# Access Compliance Report

## Public Rights-of-Way

### (Curb Ramps)

Intersection ID: 7022	Main Street: CROSSPOINT_CENTER_LN	Cross Street: HUTCHISON-MCDONALD_RD	Location: NW
ADA ID: 6446B7083CB5	Ramp Type: Perp	Initial Pass/Fail: Fail	Overall Compliance: No
Severity Score: 13.75			
Codes/Mitigation Info/Possible Solution		Field Measurements/Component Compliance

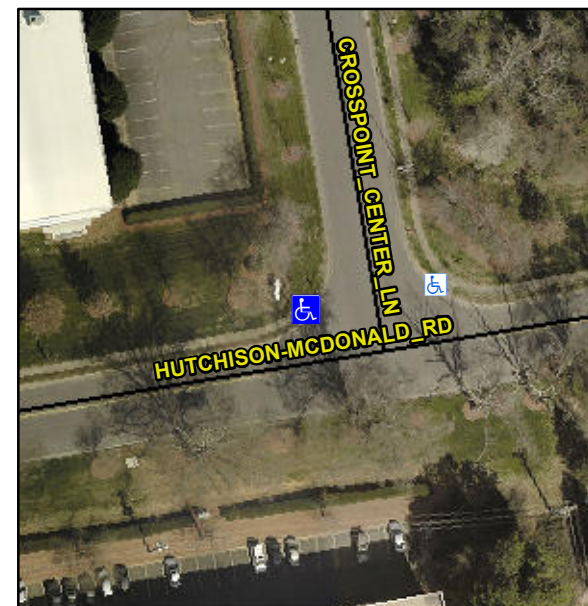
**Not Found, R304.2.2, R304.5.3**

Compliance	Description	Data	Compliance	Description	Data
N/A	Ramp Length (in)	95.5	No	Ramp Slope (%)	9.0
Yes	Ramp Width (in)	48.0	No	Ramp XSlope (%)	2.1
N/A	Flare Type LT	N/A	N/A	Flare Type RT	N/A
N/A	Flare Slope LT (%)	N/A	N/A	Flare Slope RT (%)	N/A
N/A	Flare Traversable LT?	N/A	N/A	Flare Traversable RT?	N/A
N/A	Landing Length (in)	N/A	N/A	DWS Provided?	N/A
N/A	Landing Width (in)	N/A	N/A	DWS Contrast?	N/A
N/A	Landing Slope (%)	N/A	N/A	DWS Length (in)	N/A
N/A	Landing X Slope (%)	N/A	N/A	DWS Full Width?	N/A
N/A	Landing Curb? (Y/N)	N/A	N/A	DWS Offset (in)	N/A
N/A	Shared Landing?	N/A			
N/A	Gutter Ponding?	N/A	N/A	Gutter Slope (%)	N/A
N/A	Gutter Lip Ht (in)	N/A	N/A	Gutter X Slope (%)	N/A
N/A	Painted X Walk1?	No	N/A	Painted X Walk2?	N/A
	X Walk 1 Direction	To E		X Walk 2 Direction	N/A
N/A	X Walk 1 Width (in)	N/A	N/A	X Walk 2 Width (in)	N/A
	X Walk 1 Slope (%)	0.2		X Walk 2 Slope (%)	N/A
	X Walk 1 X Slope (%)	2.8		X Walk 2 X Slope (%)	N/A

**Remove & Replace Entire Ramp.**
